# Authorized Field Change

**AFC G-03907**

**Subject:** The Hood Lower Hinge Bolts May Contact the Air Conditioning Lines in 7600 SBA Models Built at the Garland Assembly Plant before July 25, 2003

Figure 1 Lower Hood Hinge Bolts As Viewed From The Passenger Side

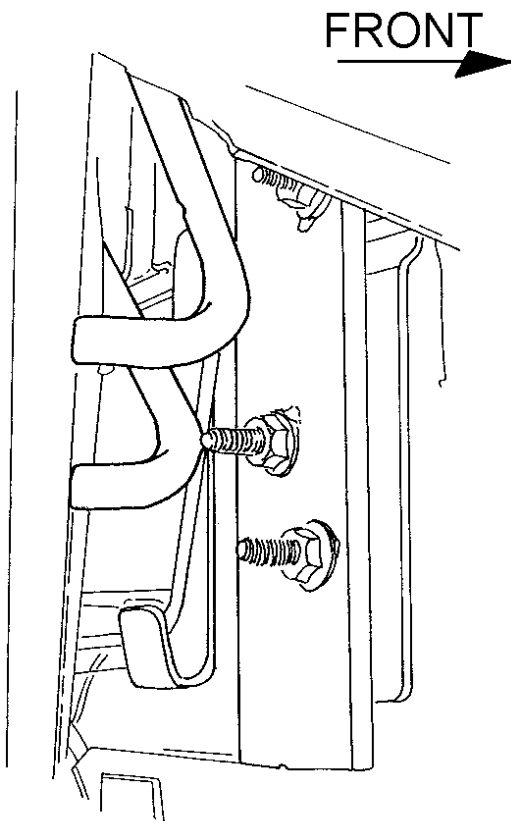
In some cases the hood lower hinge mounting bolts, on the passenger side, may contact the air conditioning lines (Figure 1) in 7600SBA Models built at the Garland Assembly Plant before July 25, 2003. This contact may cause the air conditioning lines to fail.

Effective July 25, 2003 a new bolt, Part Number 35715000C1, is used in production.

1. Open the hood and locate the two lower hinge bolts. Inspect the air conditioning lines for bolt contact. If no contact is noted and there is a minimum of 6 mm (1/4 inch) clearance, this procedure is not necessary. If inadequate clearance or bolt contact with the air conditioning lines is noted, proceed to the next Step.
